UNITED STATES
NUCLEAR REGULATORY COMMISSION

Docket No. 40-8943
SUA-1534, Amendment No. 18
04008943300E
04008943400E

SUBJECT: ENGINEERING REVIEW OF SOLAR EVAPORATION POND DESIGN FOR THE
FERRET CROW BUTTE FACILITY IN NEBRASKA

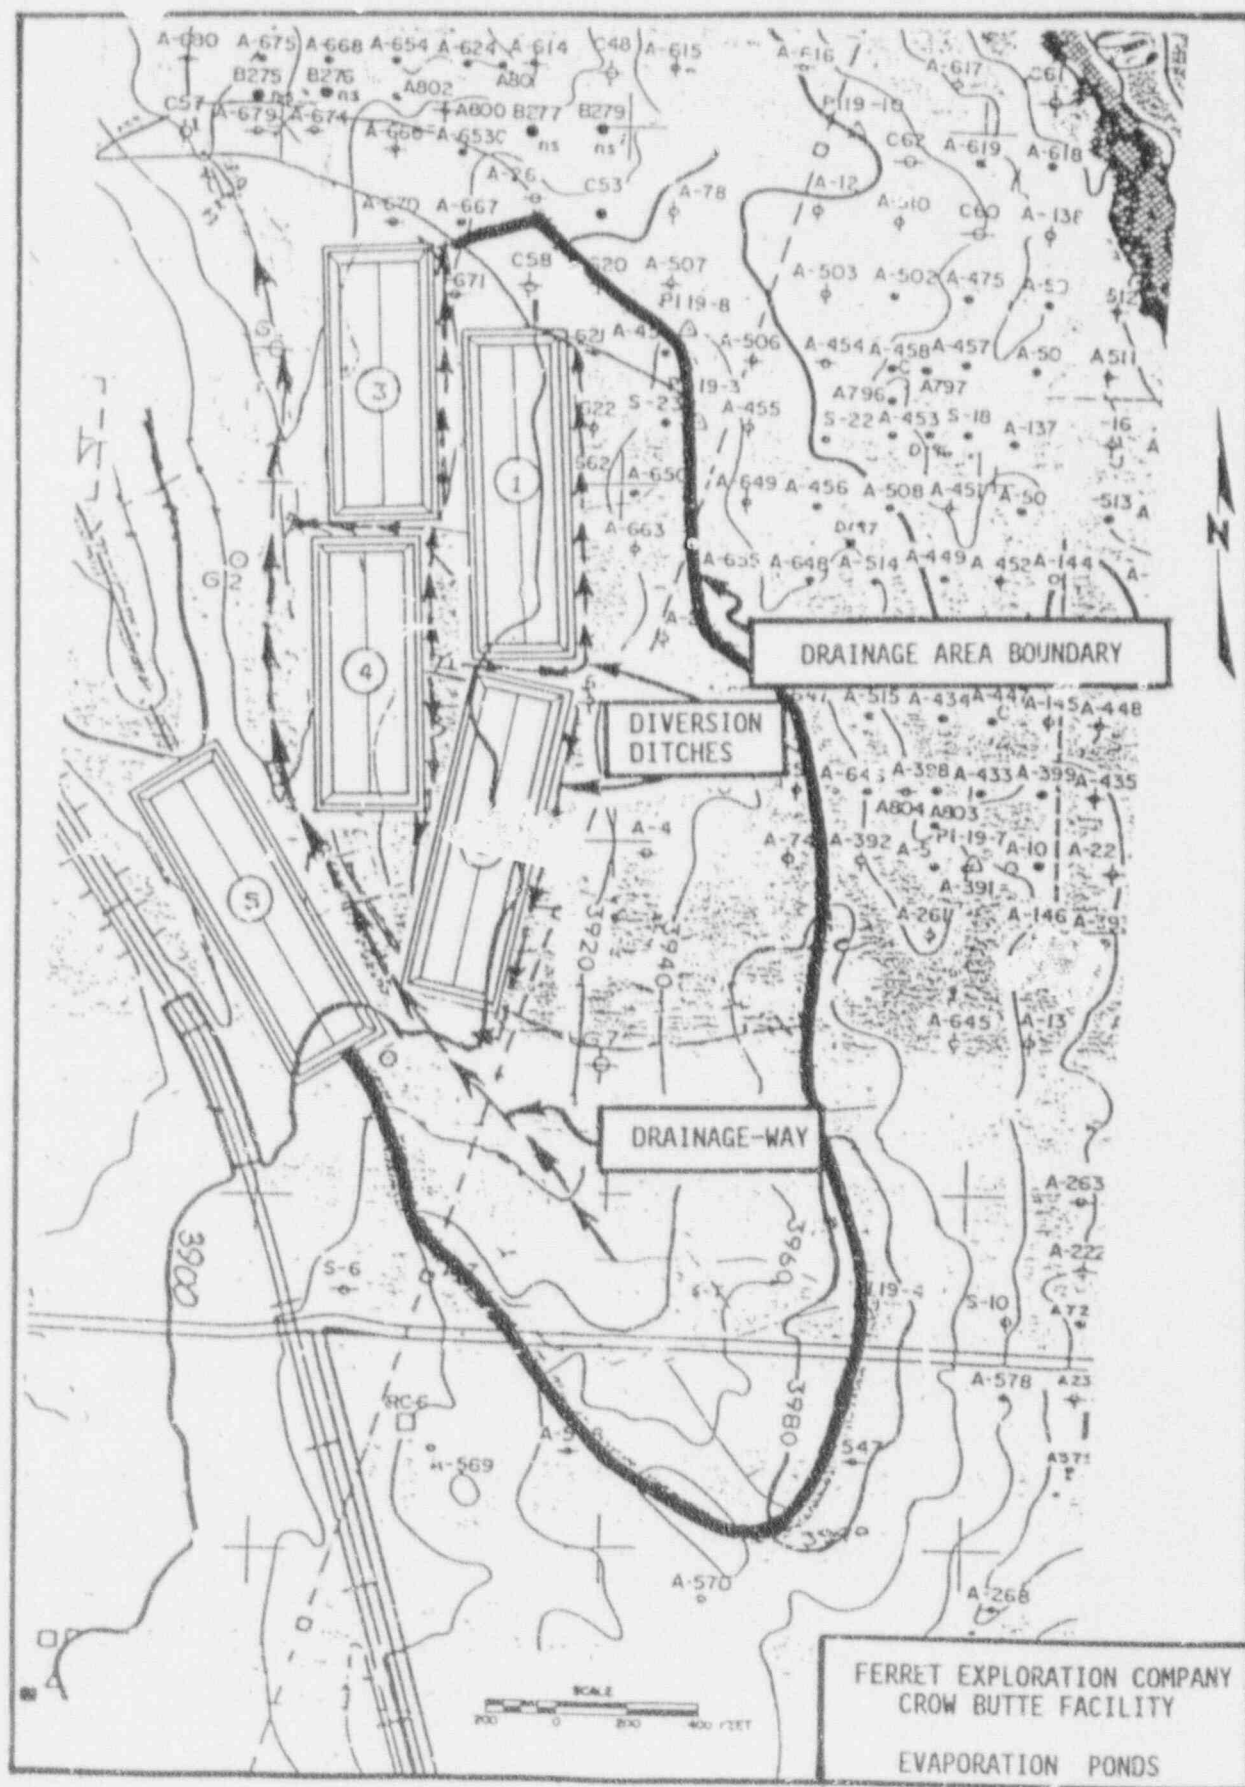
Source Material License SUA-1534, which was issued on December 29, 1989, authorized Ferret Exploration Company of Nebraska (Ferret) to operate the Crow Butte in situ leach facility. The license authorized, in part, the construction of five solar evaporation ponds as shown on figure 1. To date, only ponds 3 and 4 have been constructed.

As shown on figure 1, the evaporation ponds are located on a sloping hill side. Therefore, diversion ditches have been designed to safely divert flood flows away from the ponds. In addition, there is a drainage-way between the ponds.

FIGURE 2

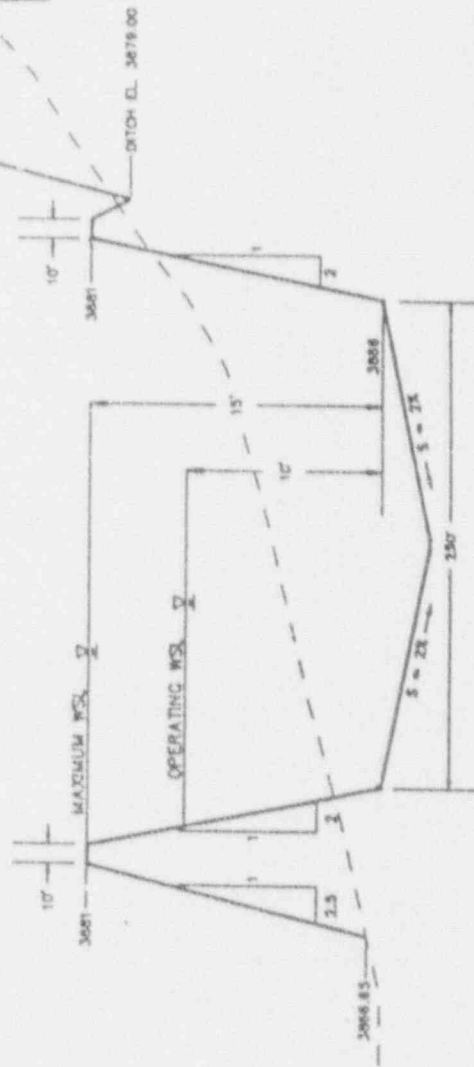
As basic input parameters for both of the licensee's analyses were not provided, an independent analysis was performed. To model the structures, the system cross section shown as section D-D in the May 23, 1988, submittal was selected as the critical section, figure 2. This section contains the inside slope of pond 3 and the outside slope of pond 1. The Bishop method of slices was used to analyze the stability of the section.

The phreatic surface through the section, figure 2, was conservatively assumed to begin at the low point in pond 1 and daylight at the toe of the inside slope of pond 3. Water level measurements made in the second quarter of 1992 indicated that the phreatic surface was well below the surface in the area. The water surface elevation at monitoring wells MW 1 and 2 located near pond 3 were reported to be 45 feet and 38 feet below the surface, respectively. No pond solutions were included in the model.

The results of the analyses indicated that the minimum factor of safety 1.6 can be expected under the prescribed conditions. This factor of safety is greater than those recommended in RG 3.11. The critical circle cut through the upper section of the pond 1 outslope near the crest and exited near the toe of the slope, above the crest of pond 3. A smaller circle with a factor of safety of 1.2 was located on the inside slope of pond 3. This circle intersected the assumed phreatic surface, hence the low factor of safety. As the assumed phreatic surface is not reasonable for lined ponds, this circle was analyzed only to demonstrate that the effect of allowing a phreatic surface to develop within the embankments. Amendment No. 17 to Source Material License No. SUA-1534 evaluated the liner system and found it adequate.
